## Riley Purgatory Bluff Creek Watershed District Permit Application Review

**Permit No:** 2023-022

**Project:** CorTrust Bank – This applicant proposes to rehabilitate most of the parking lot with some reconstruction to improve drainage. The existing stormwater pond and new tree plantings will provide runoff volume abstraction, water quality treatment, and rate control.

**Reviewer:** Heather Lau, PE & Scott Sobiech, PE, Barr Engineering

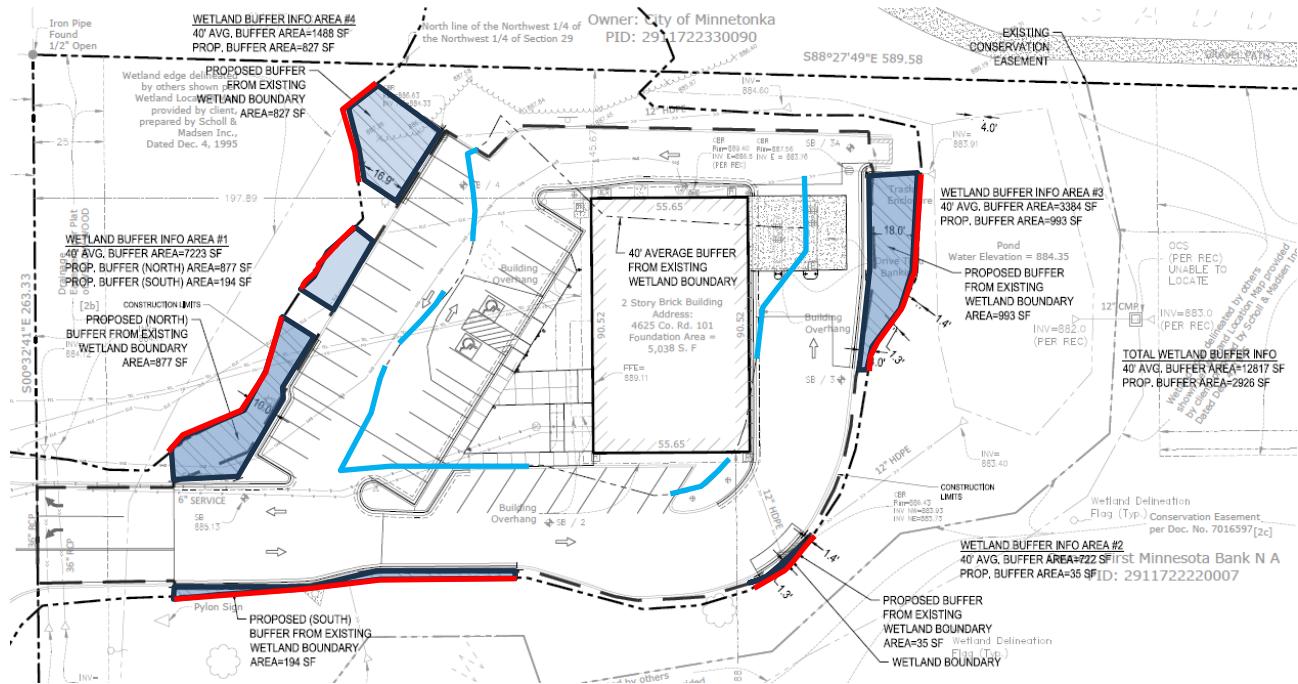
The erosion control plan includes installation of silt fence, inlet protection for storm sewer catch basins, daily inspection, placement of a minimum of 6 inches of topsoil, decompaction of areas compacted during construction, and retention of native topsoil onsite. To conform to the RPBCWD Rule C requirements the following revisions are needed:

- C1. The Applicant must provide the name and contact information of the individual responsible for erosion control at the site. RPBCWD must be notified if the responsible individual changes during the permit term.

WETLAND BUFFER  
EXHIBIT

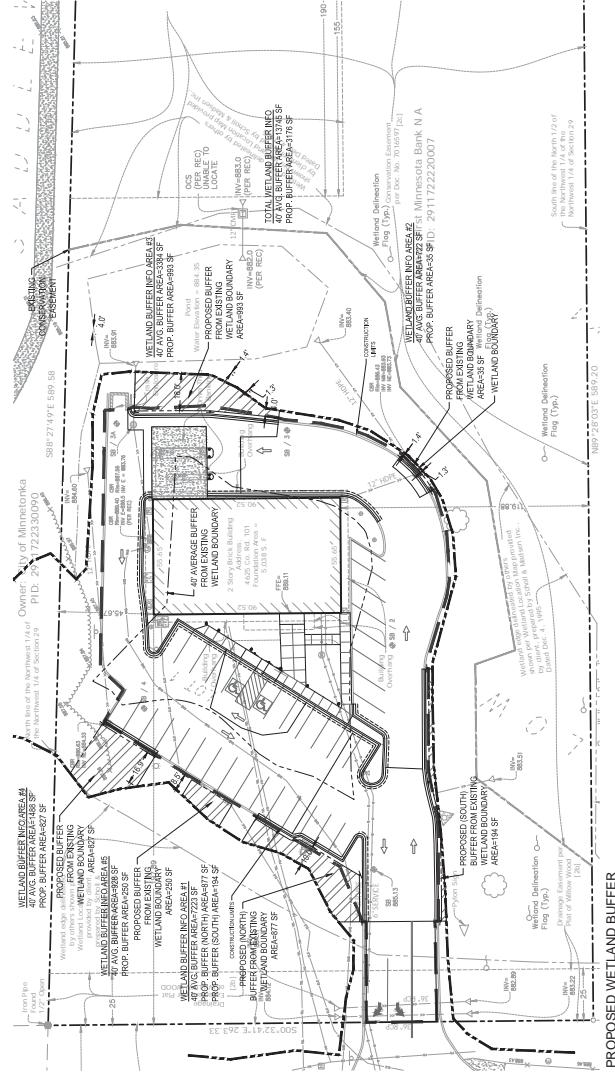
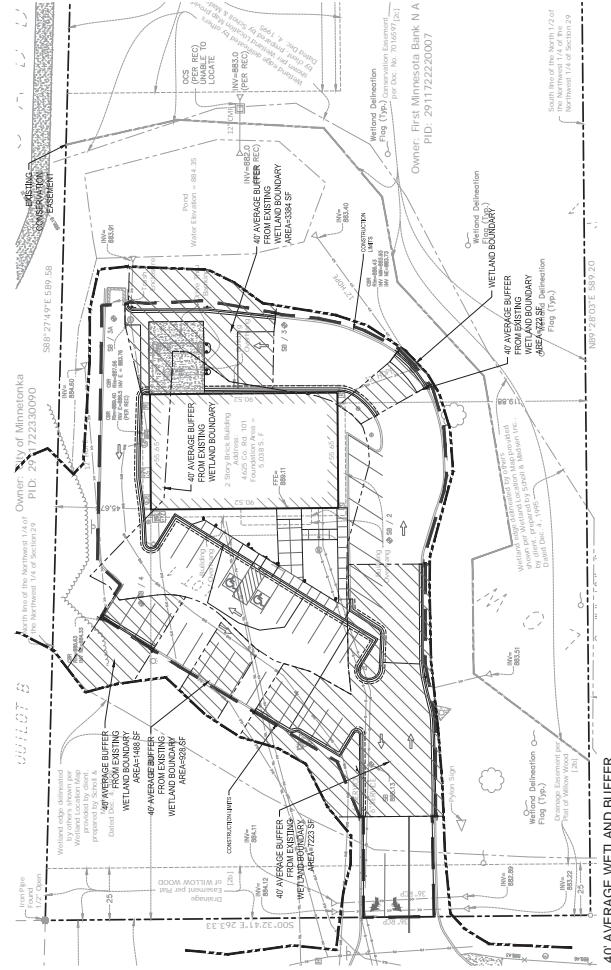
The MnRAM analysis submitted indicates that the wetland onsite is a medium value (Appendix D1). Rule D, Subsection 3.2.b.iii requires a wetland buffer with an average of 40 feet from the delineated edge of the wetland, minimum 20 feet on the edge of the wetland that is downgradient from the land-disturbing activities. The figure below illustrates the onsite wetland boundary that is downgradient from the land-disturbing activities (red line), proposed buffer (dark blue), and 40-foot offset line from wetland boundary (bright blue).

Using buffer averaging (subsection 3.2e) the require buffer area for a 40-foot width buffer adjacent to the wetland is 12,817 square feet. The applicant's proposed buffer totals 2,926 square feet with an average width of 9.1 feet and a minimum width of 0.1 feet. The applicant has requested a variance from the criteria of Rule D, Subsection 3.2.b.iii that require a minimum 20 feet buffer width from the delineated edge of a medium value wetland and associated average buffer area (13,067 sq ft), and from subsection 3.3d, which prohibits reconstruction of impervious surface within the buffer area (see variance discussion below).

The variance request is from the minimum width requirement for a medium value wetland (Rule D, Subsection 3.2.b.iii). Subsection 3.1.a.iii states that buffer with a minimum width of 20 must be created. The applicant also requested a variance from Rule D, Subsection 3.3.d, to allow the reconstruction of the impervious surface within the minimum buffer width (subsection 3.3.d). Because the two variance are

- Related to variance criterion 1 – The proposed wetland buffer will have minimum width of 0.1 feet, which is less than 1% of the required minimum from the entrance road.

- With regard to variance criteria 2 and 3 – The information submitted demonstrates that the proposed buffer minimum width of 0.1 feet will not have an adverse effects to the resource because the runoff from the impervious surface on the site, which is within the minimum 20 foot width, is routed to the existing stormwater facilities for treatment prior to runoff entering the wetland.

- Technical measures considered to alleviate the practical difficulty (variance criterion 4) was reducing the pavement widths. This is not feasible due to functionality concerns and the need to create a continuous curb and gutter (C&G) line between section of undisturbed C&G . Placing the reconstructed C&G at the minimum buffer width would create impassible drive lanes.

The engineer finds there is adequate technical basis for the managers to rely on to grant the requested variance from the minimum buffer width for the wetland and allowing the reconstructed of the impervious surface within the minimum buffer width.
